AMA Designer's Response

Proposed Residential Development – Westgate, Cleckheaton

21st March 2022

Road Safety Audit: Stage 1-S278 and S38

Appendix 2 – Problem Location Plan

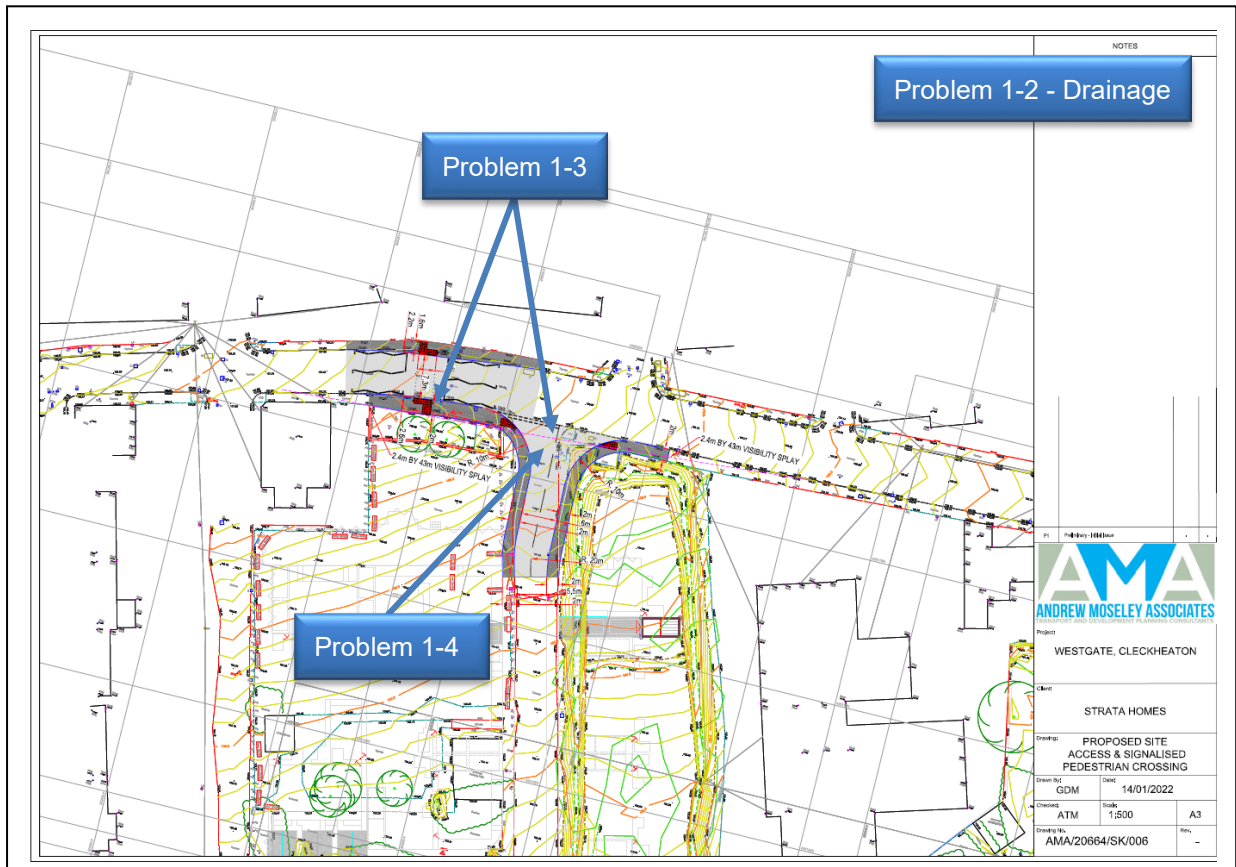
This section details the findings of this Stage 1 Road Safety Audit. All locations of identified problems are illustrated on the plan included at **Appendix 2**.

Appendix B – Proposed Site Access & Signalised Pedestrian Crossing

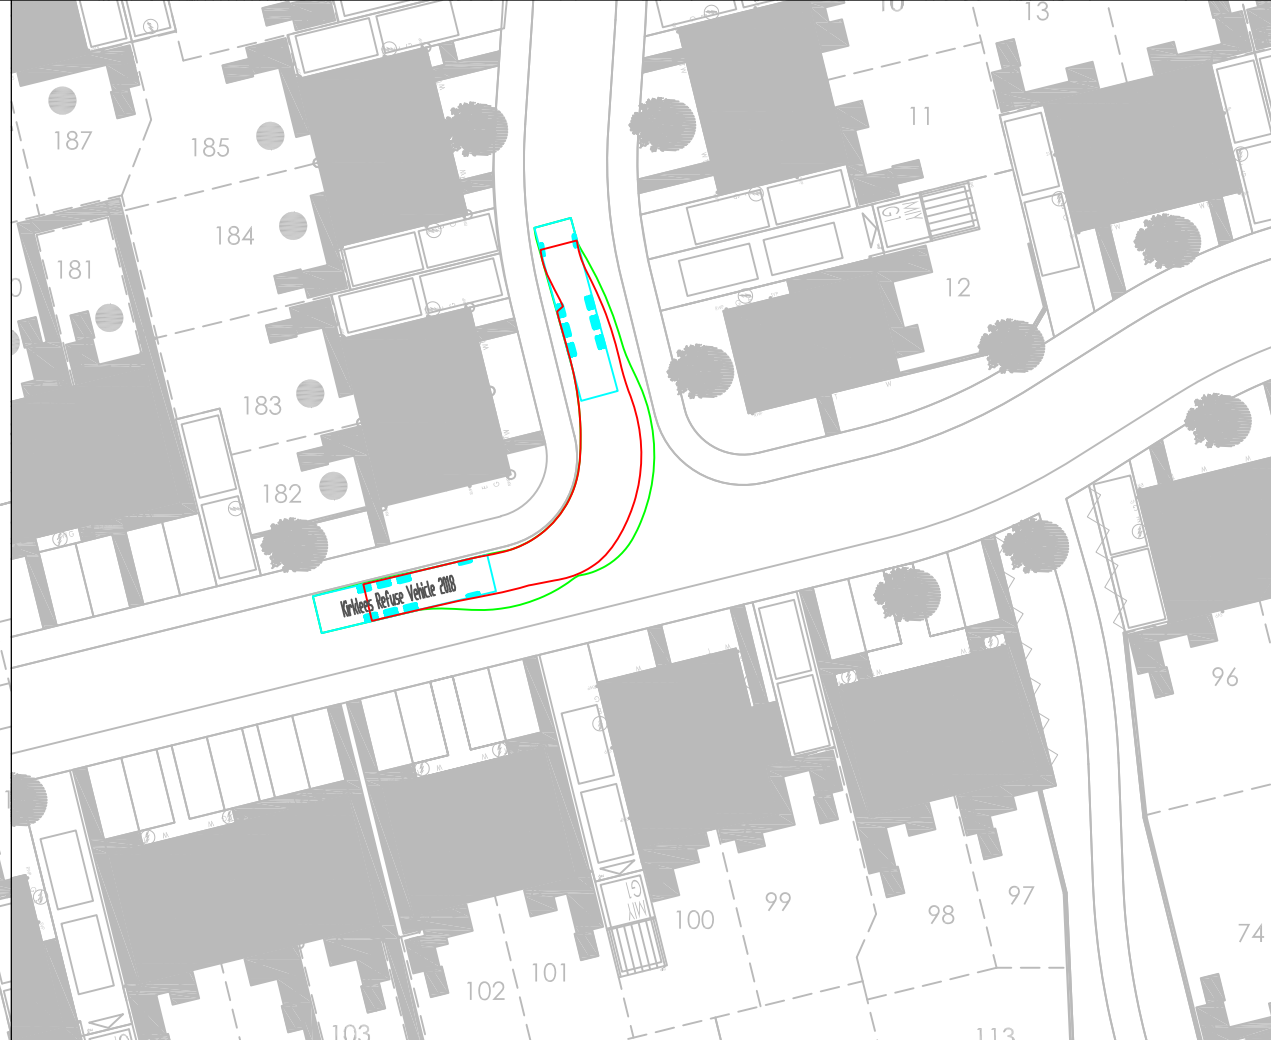
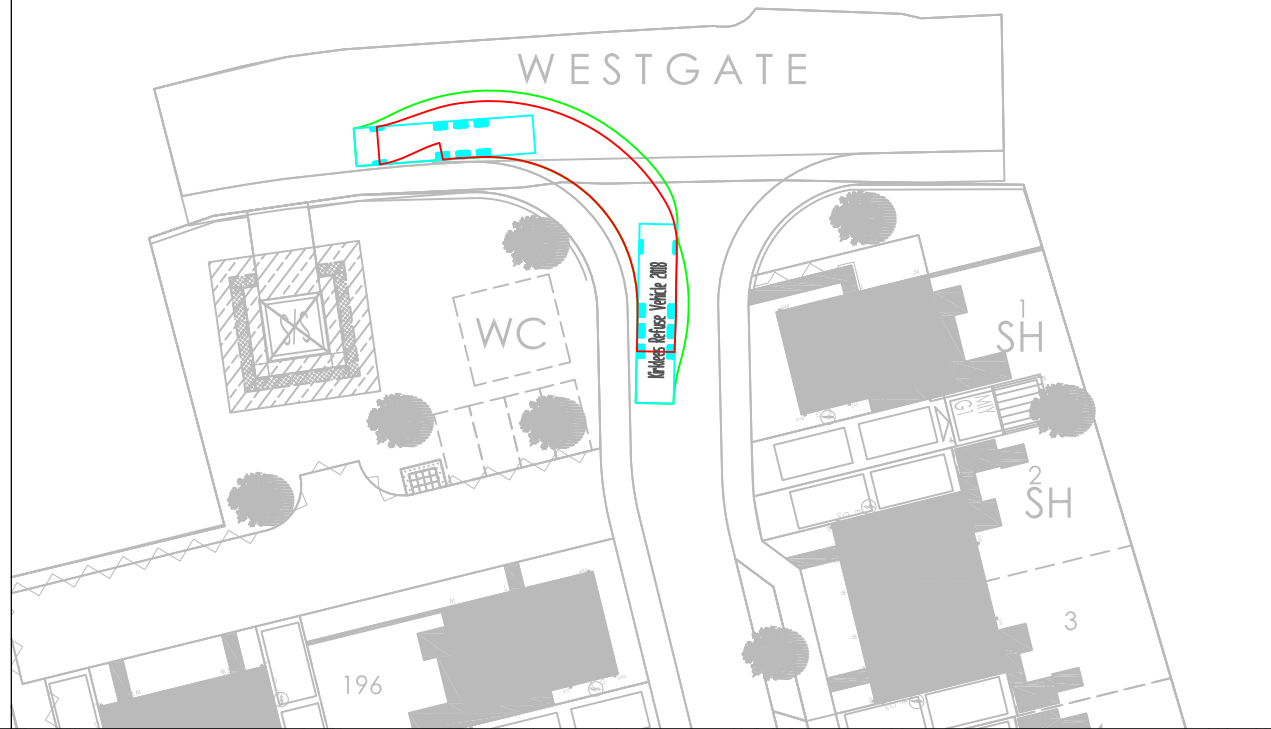
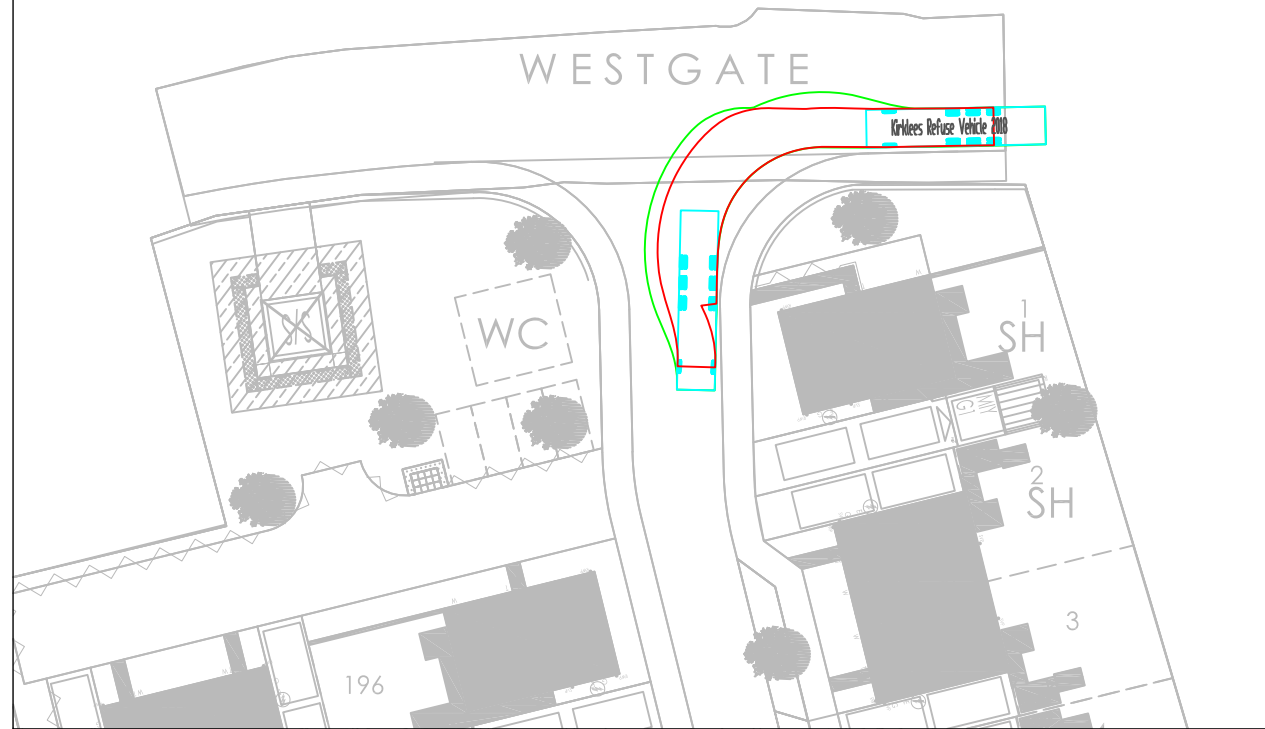
Uncontrolled and controlled crossings that do not comply with DfT standards will increase the risk of pedestrian/vehicle collisions.

Summary: *The drawings provided have two identified problems the first is that the uncontrolled crossing of the site access has red tactile which is specific to controlled crossings and not uncontrolled crossings. The second issue is that the leg of a controlled crossing must be only three tactile paving slabs wide the drawings shows that the southern tactile paving at the proposed signalised crossing is greater than three tactile paving slabs wide.*

Provide buff coloured tactile at uncontrolled crossings and provide tactile paving layouts that meet the required standard at controlled crossings.

The uncontrolled access crossing and the signal controlled pedestrian crossing to the west of the application site have been updated to comply with DfT standards. Details of the pedestrian crossings are provided in SK006, attached at **Appendix B**.
